Division of Reclamation,
Mining and Safety

**RE: *Western Slope Flagstone Quarry No. 2, File No. M-1996-076 Acreage Release (AR-1)
Request, Adequacy Review - 2***

You have requested modifications to the Mining Plan Map and Reclamation Plan Map. Mr. Fontanari has prepared drafts of the Maps, being the Modified Mining Plan Map, Modified Reclamation Plan Map, and Addendum A to Modified Reclamation Plan Map "Current and Revised Water Facilities".

(112) PERMIT- MIDDLE AREA MINING & PHASEING PLAN

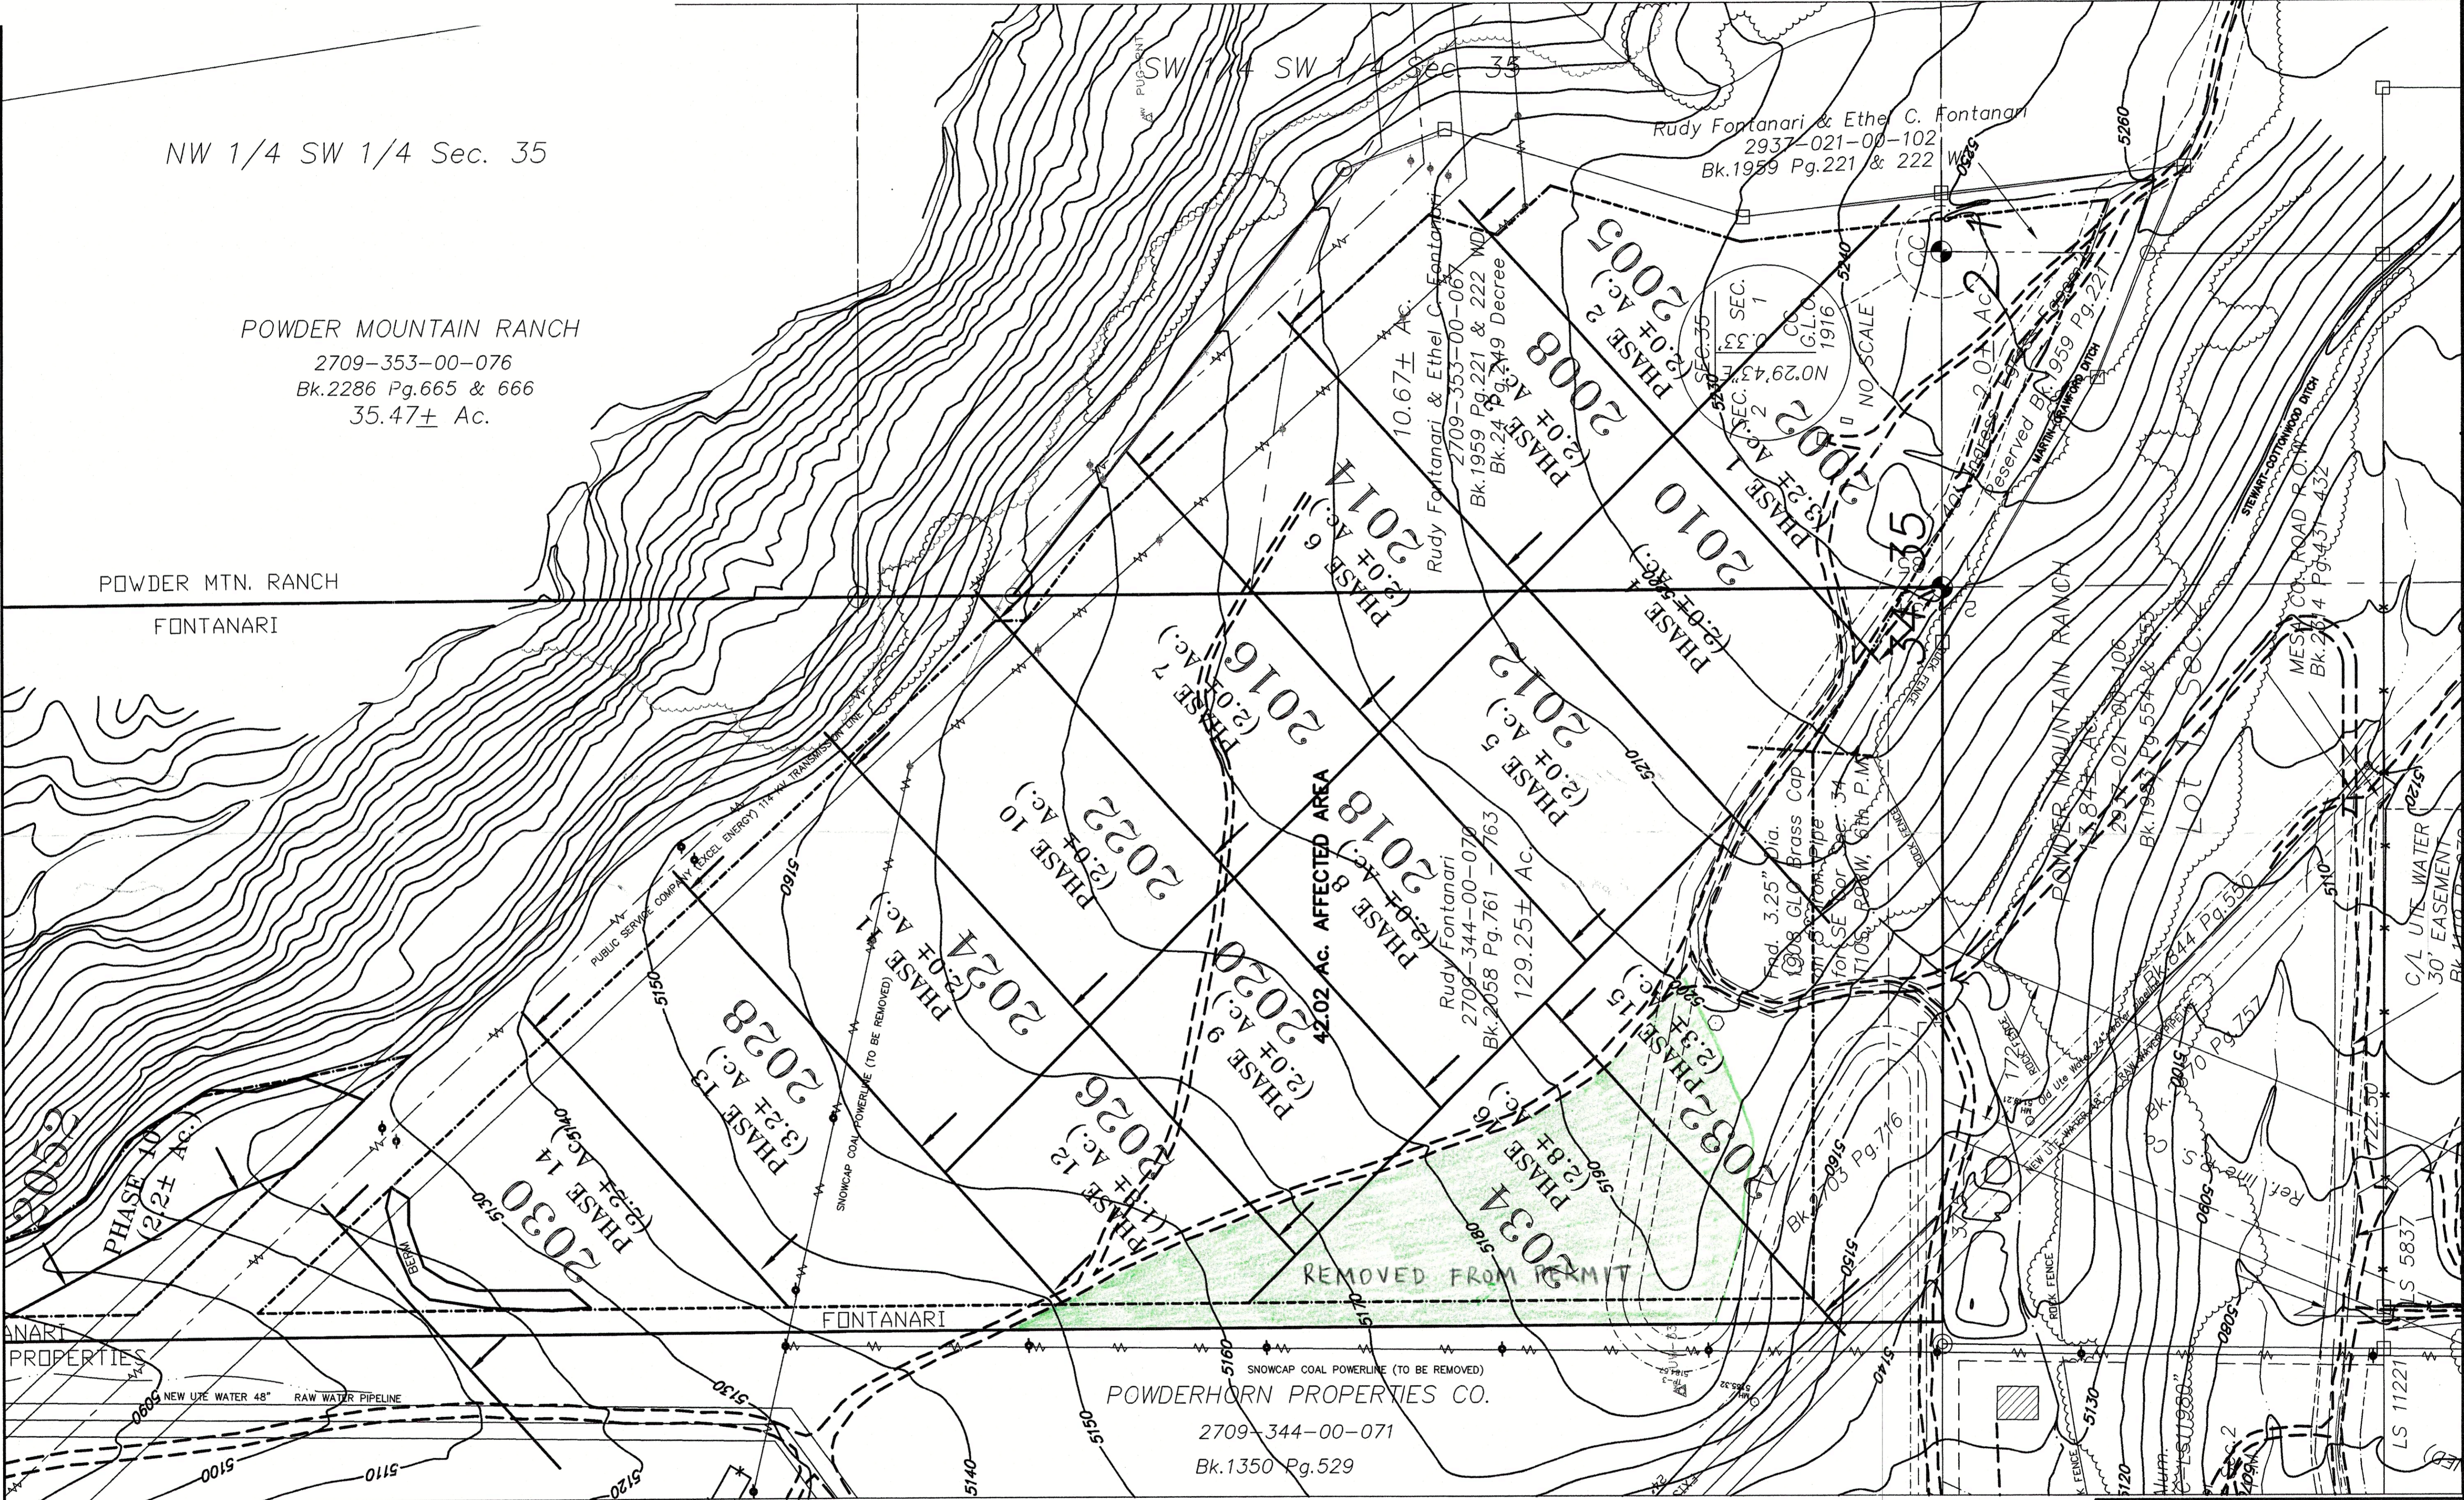
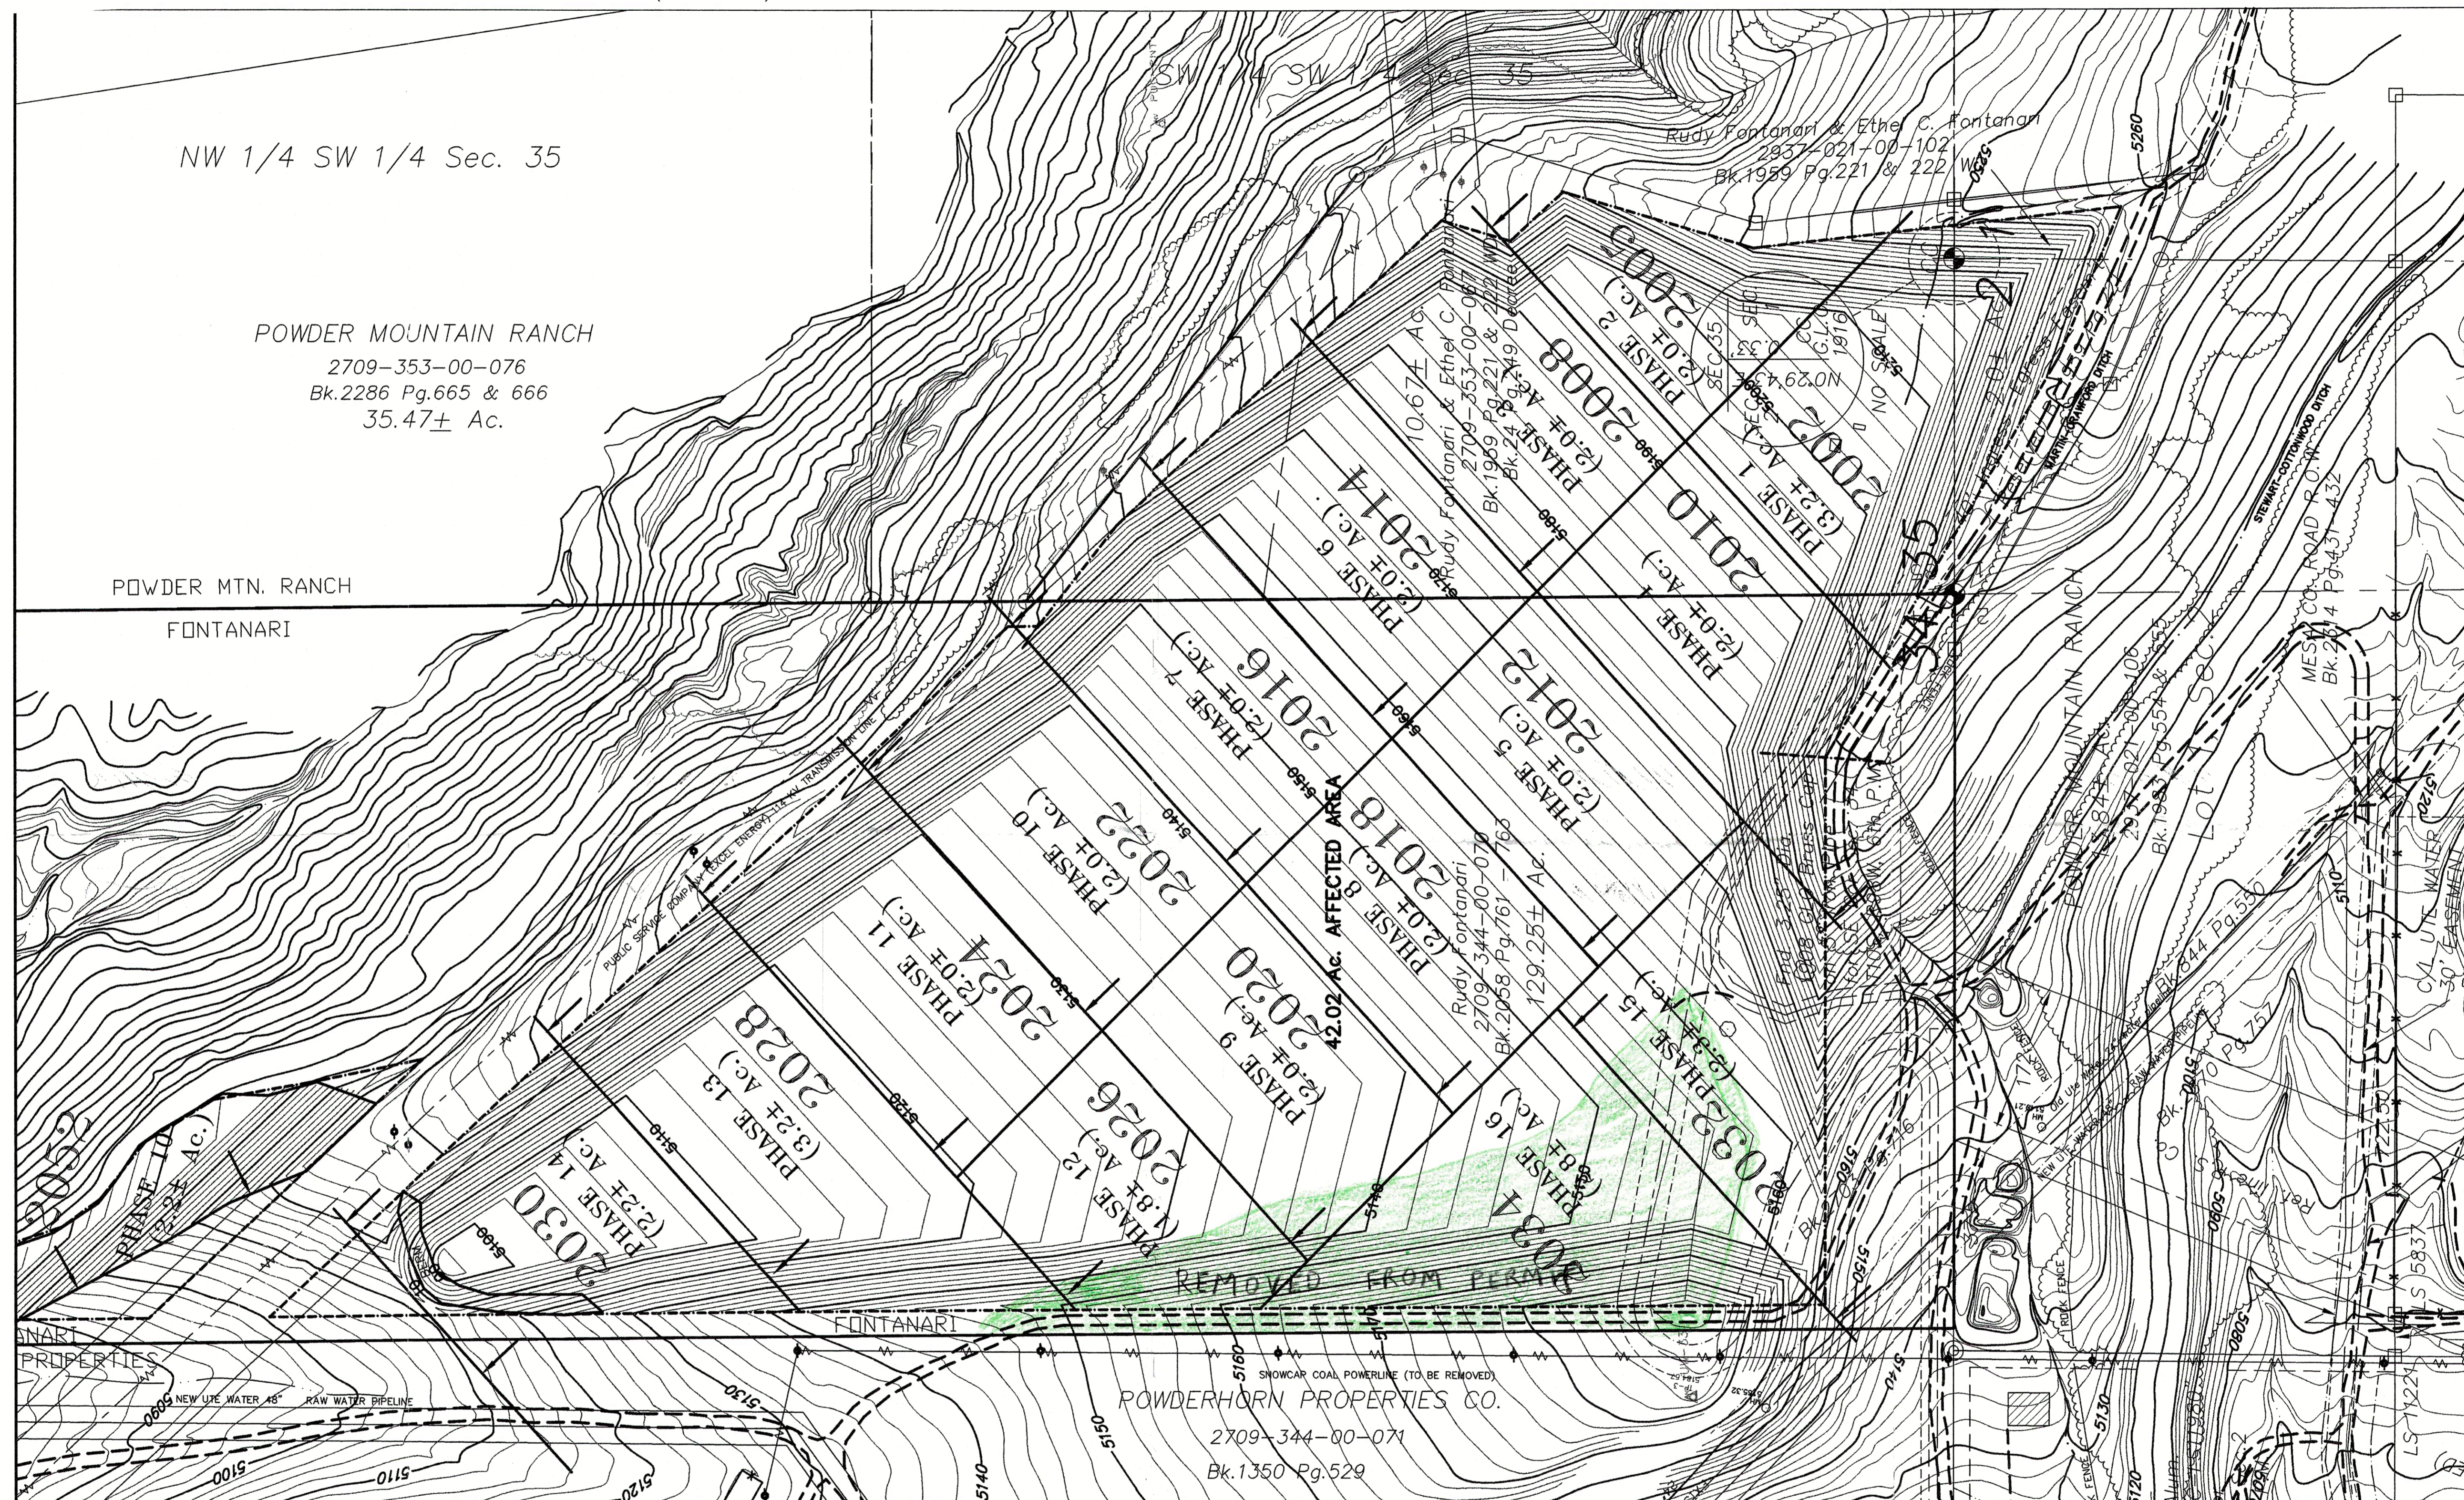
Mining Plan Map:

1. Rule 6.2.1(2)(d) – the permit boundary line has not been updated, nor does it depict the entire permit area,
2. Rule 6.4.3(d) – the Division does not have a mining plan map that shows the entire extent of the affected lands,
3. Rule 6.4.3(a) - adjoining owners of record listed are incorrect, land is no longer owned by Powder Mountain Ranch or Powderhorn Properties Co.
4. Rule 6.4.3(b)/(g) - list of structures/utilities has not been updated
5. The anticipated mining phases/dates are inaccurate/misleading. Map(s) should be updated to reflect current progress thus far,

The current map is extremely hard to read, given the amount of information conveyed in a single black and white map. The Operator may wish to use several maps to convey all of the required information of Rule 6.4.3,

(112) PERMIT- MIDDLE AREA RECLAMATION & PHASEING PLAN

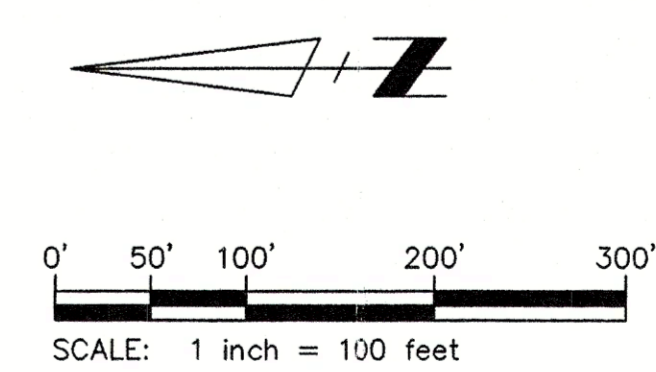
Reclamation Plan Map:

6. Rule 6.2.1(2)(d) – the permit boundary line has not been updated, nor does it depict the entire permit area,
7. Rule 6.4.6(a) - topo lines are not representative of anticipated final land configuration. If the removed field will not be mined, adjacent areas would need to be sloped from the edge of the new permit boundary,
8. Water conveyance features are not depicted, meaning they would need to be removed prior to completion of final reclamation,

9. Dates for reclamation phases would need to occur after mining has concluded and are therefore inaccurate,
10. Adjacent landowners need not be included on reclamation maps and are inaccurately listed,
The current map is extremely hard to read, given the amount of information conveyed in a single black and white map. The Operator may wish to use several maps to convey all of the required information of Rule 6.4.6,

9919PRO2

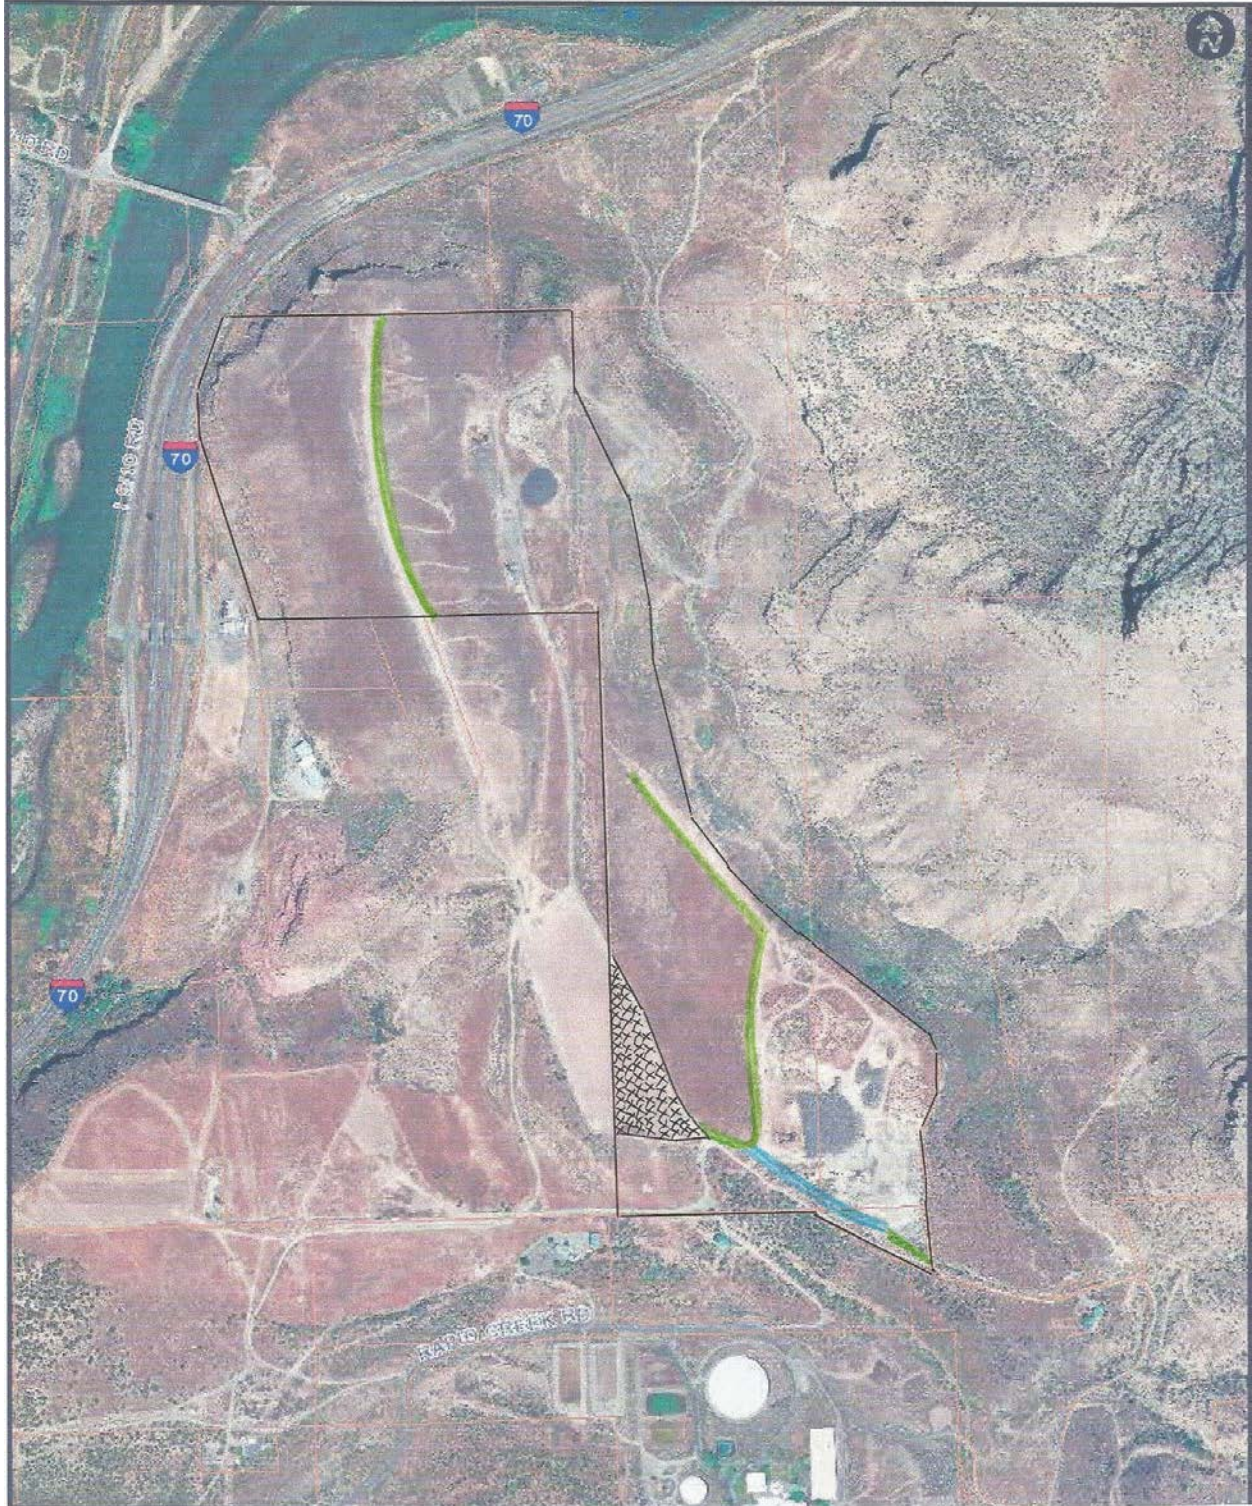
Water Map:

11. Does not comply with Rule 6.2.1(2)(a),(b),(c), and possibly (e) no scale provided.
12. Unclear if this is an Exhibit G Map 6.4.7 or just another map showing some of the features on site 6.4.3(f)
